Access Compliance Report

Public Rights-of-Way

Intersection ID: 1003388	Main Street: WOODLAND_HILLS_RD	Cross Street: N/A	Location: SE
ADA ID: 855F5E6A9EAC	Ramp Type: Perp	Initial Pass/Fail: Fail	Overall Compliance: No
Severity Score: 13.75			
Codes/Mitigation Info/Possible Solution		Field Measurements/Component Compliance

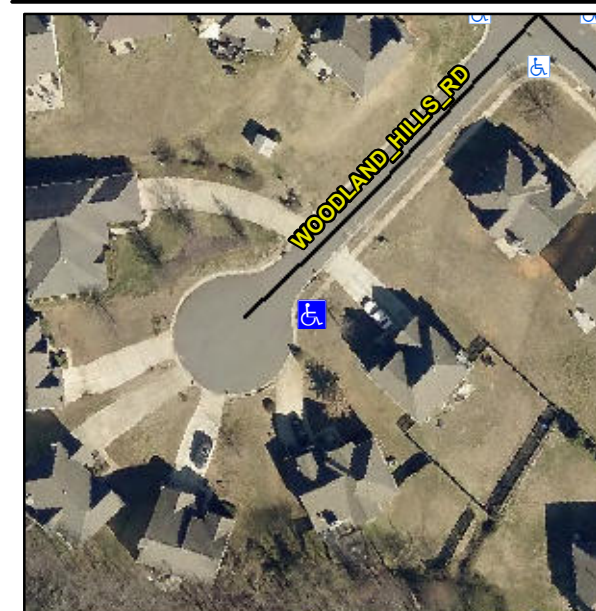
PROW/ADA:

Not Found, R304.2.2

Remove & Replace Entire Ramp.
